UNITED STATES PATENT AND TRADEMARK OFFICE

APPLICATION NO.	FILING DATE	FIRST NAMED INVENTOR	ATTORNEY DOCKET NO.	CONFIRMATION NO.
10/727,760	12/03/2003	Jim Mali	ARTCP050	7568

Office Action Summary

DETAILED OFFICE ACTION

FIG. 4

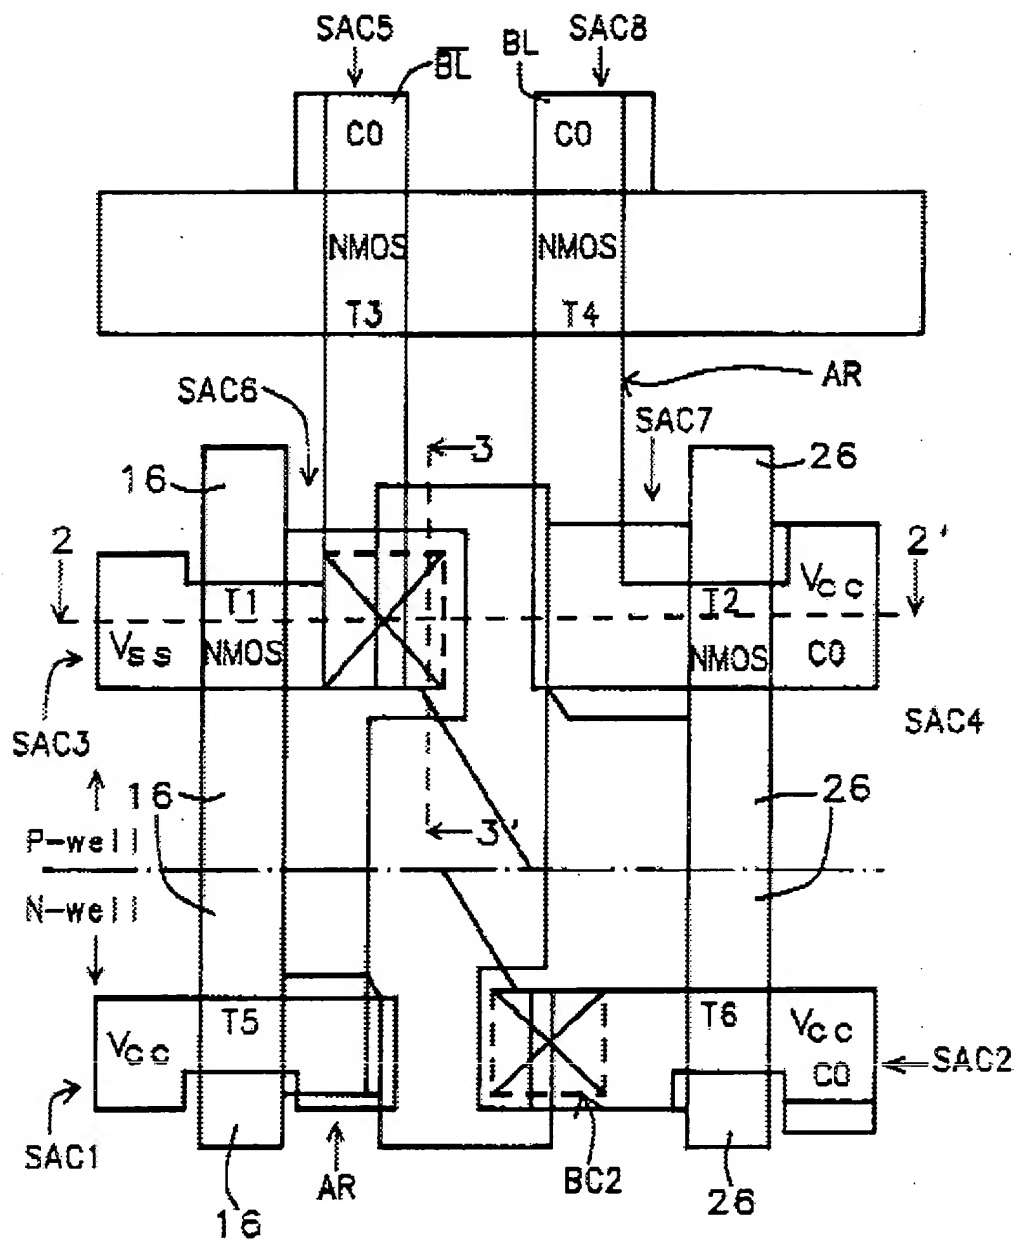
Applicant discloses in paragraph [0012] that the n-type transistor is fabricated on an n-type substrate and the p-type transistor is fabricated on a p type substrate. This disclosure is different from a conventional well known structure as shown in fig 4 in US patent 5,843,816 by Liaw that shows that N-type is fabricate on P-well (or P substrate) and P-type is fabricate on N-well (or N-substrate); also see fig 4-2 (a) page 137 From Silicon Processing for the VLSI Era (volume 3) by Stanley Wolf published by Lattice press (1995) attached to the PTO-892 of this Office Action.

Can the Applicants give evidence of prior art that have a P-type transistor (a MOSFET transistor that the source and drain are P-type) that have a P-channel built on a P substrate or a N-type transistor (a MOSFET transistor that the source and drain are N-type) that have a N-channel built on a N substrate with a n-channel since the Examiner is not aware of those structure.

FIG. 17

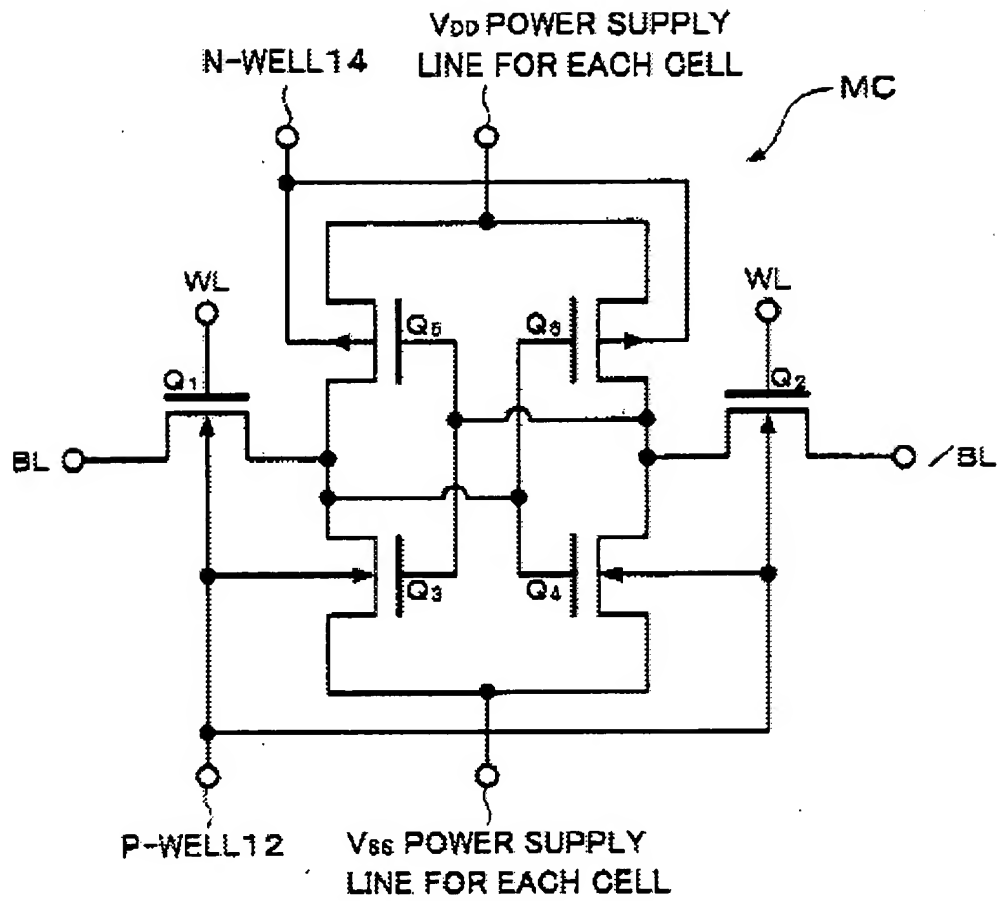
Kumagai (the abstract , fig 17, fig 19) discloses a core cell (a SRAM cell) fabricated upon a substrate of three columns of substrate material, the three columns of substrate material comprising a first n-type column, a first p-type column and a second n-type column, the p-type column being positioned between the first and second n-type columns and a random access memory comprised of at least a plurality of core cells, a core cell, comprising: first n-type substrate; first p-type substrate; and second n-type substrate, the first and second n-type substrates being positioned on opposite sides of the first p-type substrate.

FIG. 19

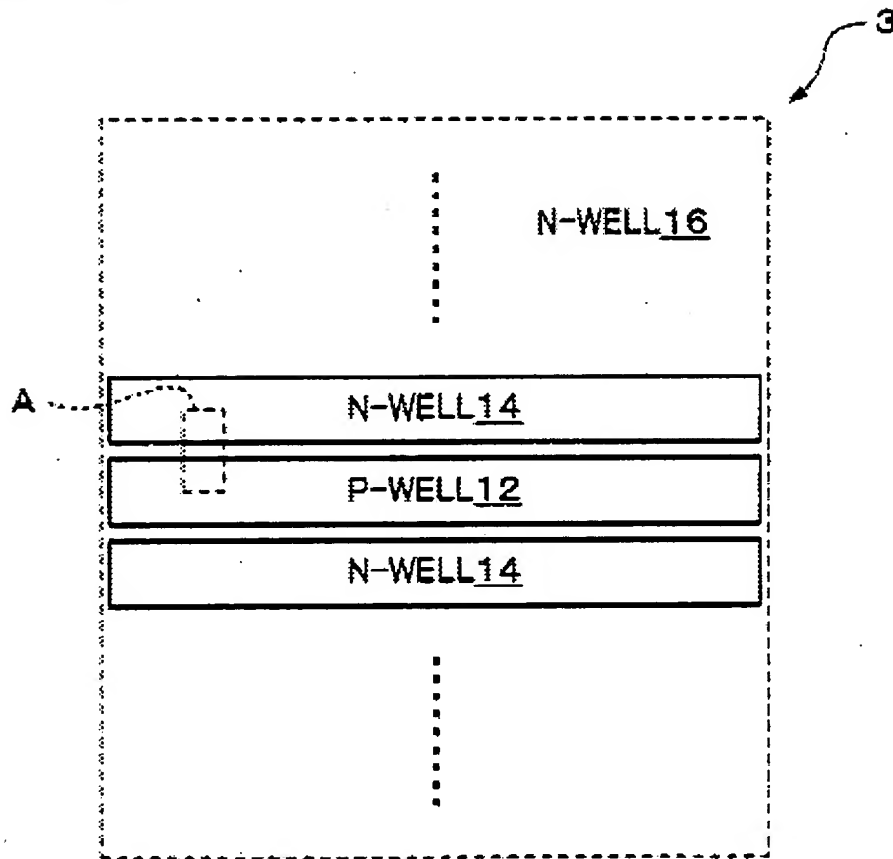
Kumagai disclose (in fig 19) a core cell wherein the substrates have rectangular shapes.

FIG. 3C

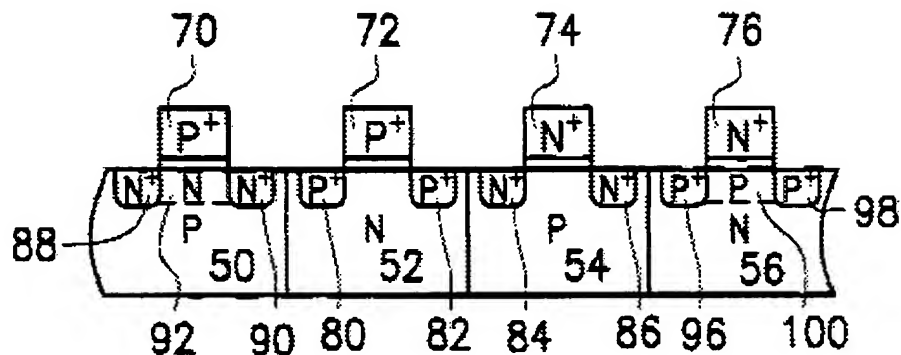
Wang disclose a first and second n-type (layer 52 and 56 in fig 3C with a p type (layer 54) in middle (fig 3C) and his structure are intended for use in SRAM fabrication.(column 1 line 20)
